**Board of Zoning Adjustment
Staff Report**
July 6, 2015

Case No:	15Variance1019
Project Name:	Taco Bell
Location:	1805 South Brook Street
Owner(s):	Louisville/Jefferson County Metro Government
Applicant:	Adam Macke, GPD Group
Representative:	Adam Macke, GPD Group
Project Area/Size:	1.09 acres
Jurisdiction:	Louisville Metro
Council District:	6 – David James
Case Manager:	Sherie' Long, Landscape Architect

Board of Zoning Adjustment Staff Report

Attachment 3 - Site Plan

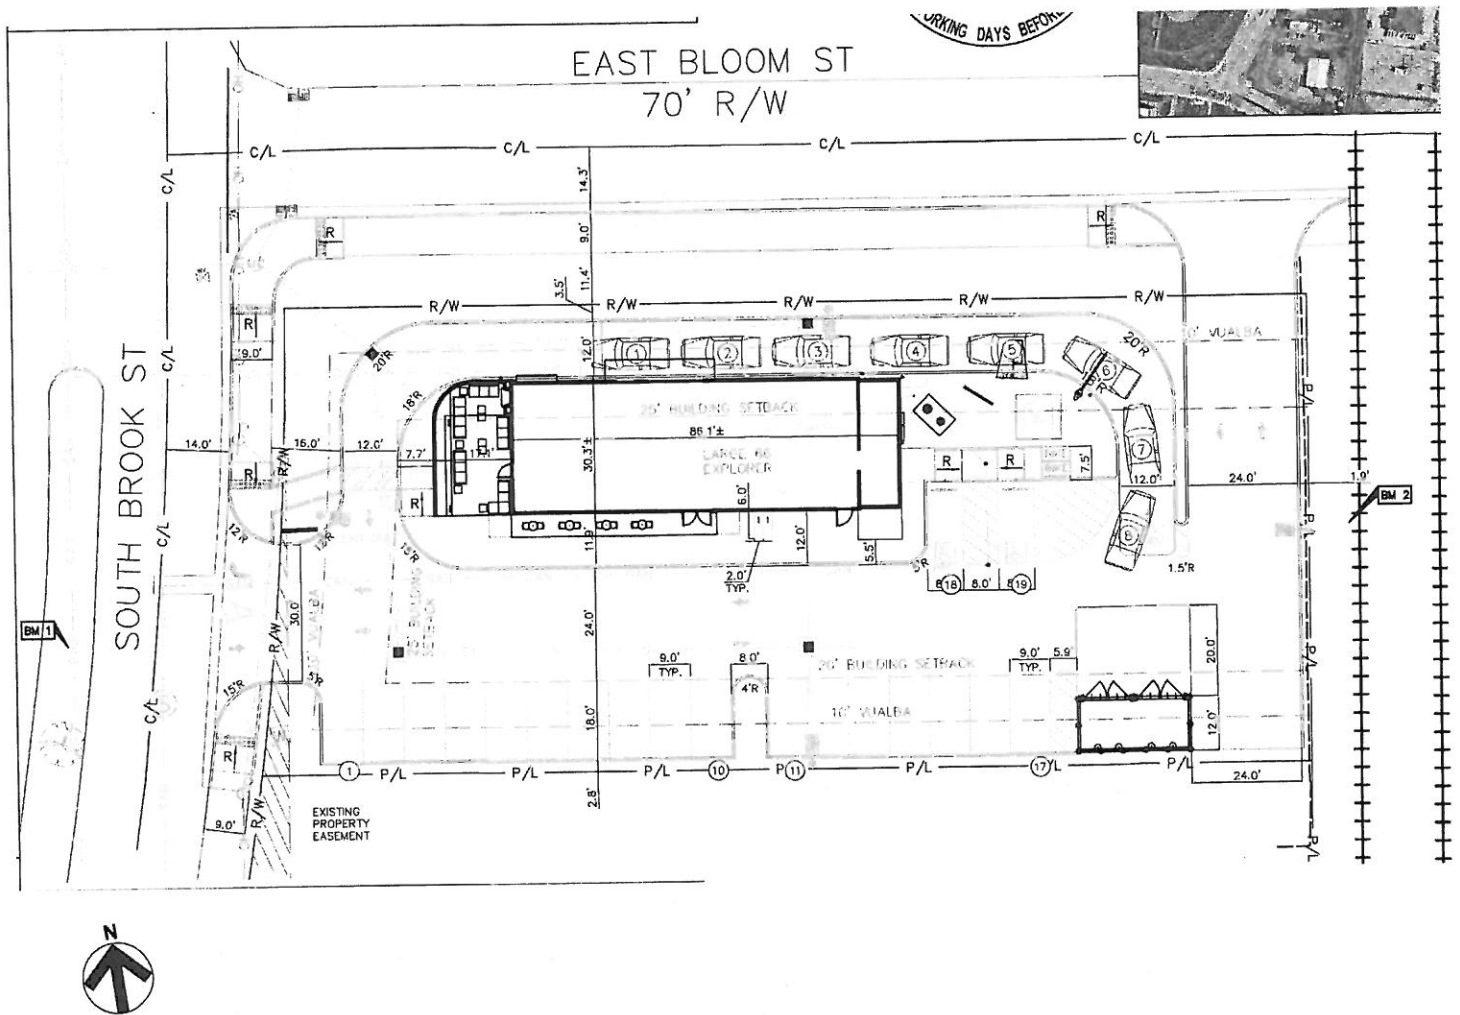
The applicant should resubmit an updated development plan addressing the following technical review items:

1. Add the boundary calls for the perimeter property lines to the plan. Show the property lines as solid lines.
2. Add the adjacent property owner information to all perimeter properties; include the address, deed book & page, form district, and zoning.

3. Label the railroad right-of-way along the rear of the property.
4. Add the right-of-way widths to the streets.
5. Show and label the dimension from the street centerline to the property line.

6. Show drainage flow arrows on the plan. Show the locations of catch basins and inlets.
7. Show and label the contours.
8. Show and label utility easements.

9. Show and label easement for existing tower if it is to remain.
10. Clearly identify the new building and site elements on the plan. Including the menu board, dumpster, outdoor seating, etc.

11. Show the existing building and label as being removed.
12. Provide the square footage of the outdoor seating area.
13. Correct the parking calculations to show the outdoor seating area parking requirements.

14. Add the Floor Area Ratio (FAR) to the site data.
15. Along the East Bloom frontage: Add a dimension from the building to the property line; and add a dimension from the menu board to the property line.

16. Add an over-all dimension from the property line to the South Brook Street face of the building.
17. Show and label the 20' setback along the rear property line.

18. Add a typical parking module with dimensions for parking spaces, aisles and accessible spaces.
19. Show and label the ILA areas on the plan. List the square footage of each on the plan clearly.

20. Label the grass median in the South Brook Street right-of-way.
21. Add a note to the plan addressing repair of existing sidewalks.
22. Clearly show a pedestrian connection from East Bloom Street as well as South Brook Street.

23. Add a note to the plan addressing the driving aisle connecting to the adjacent property to the south. Provide a crossover agreement for this proposed access.
24. Add this note to the plan: All work within the right-of-way will require construction plans, permit, and bond.
25. Replacement sidewalks along East Bloom Street should be 9' wide.
26. Applicant shall address the MSD water quality and stormwater management requirements and comments provided.
27. 75% of the length of the façade facing East Bloom Street shall be animated with building façade features as listed in the Land Development Code.

The applicant has provided a revised development and landscape plan which resolves the 27 Technical review items listed in the staff report dated June 15, 2015 (included as attachment 4)

Attachment 4 –Building Elevations

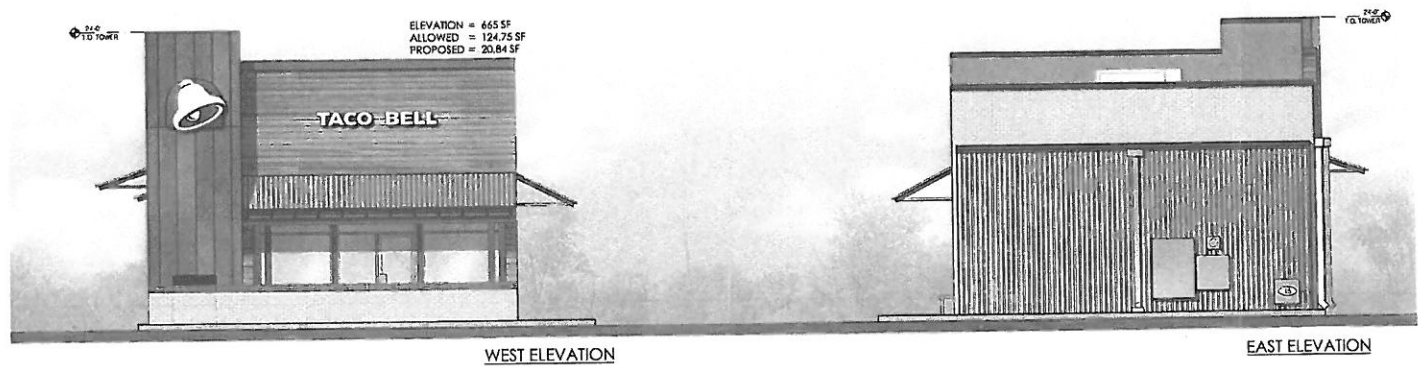
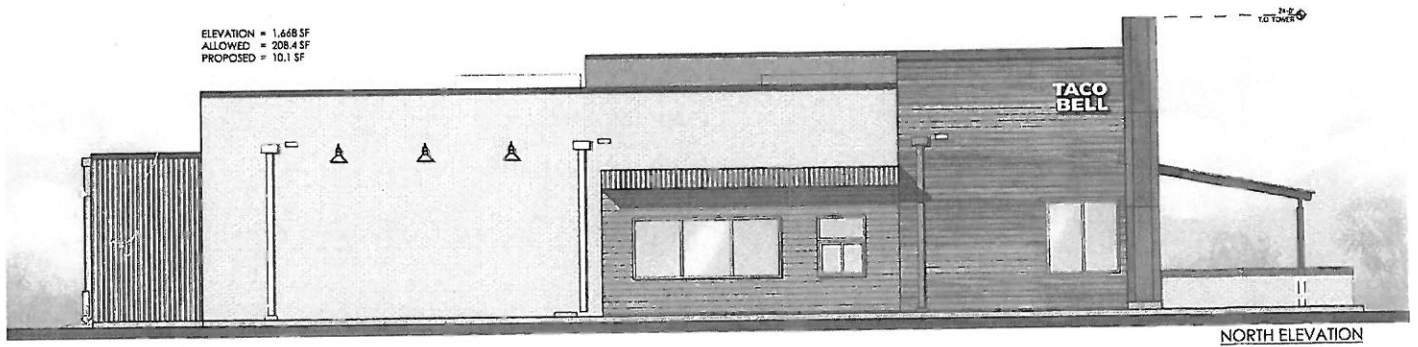
STAFF: The waiver will not adversely affect adjacent property owners since the applicant is providing entrances from the parking lot and the front of the building facing South Brook. To provide an entrance

on the East Bloom Street facade would require pedestrians to cross the drive-thru traffic lane which could be unsafe and dangerous. The design of the interior kitchen and equipment does not allow the required 50% of the wall surface to be clear glass; however, not providing the clear glass will not affect the adjacent property owners.

The applicant has provided a revised plan which addressed the technical review comments along with landscape requirements. To meet the 60% animation requirement, a mural has been added to the South Brook Street façade.
